RE: DA2017/0206: 1113 OXFORD FALLS ROAD FRENCHS FOREST

We have been requested by the applicant to prepare a brief response to Council's Urban Design Referral comments in relation to the subject application. The Urban Designer raises three issues, as follows:

UD Rfi

Figure 6 - 14 Karabah Place, Frenchs Forest

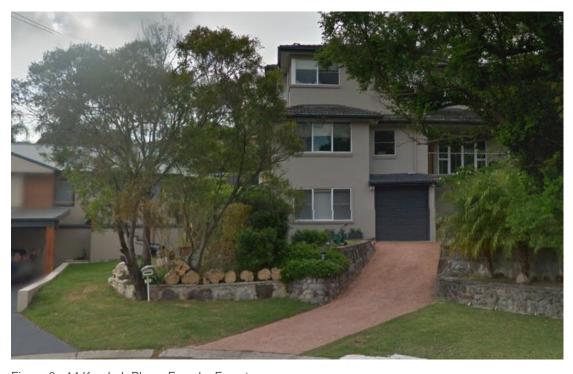
Indeed, the **attached** desk-top survey of the surrounding locality clearly demonstrates that 3 storey housing is not uncommon nor incompatible within the local 'detached housing context'.

The proposed 3 storey housing in this DA is therefore consistent with both the "detached style housing" description in the DFCS applying to the site and the context and style of housing in the immediate locality of the site. Therefore, we believe the objection to the buildings based on the number of storeys is not supportable.
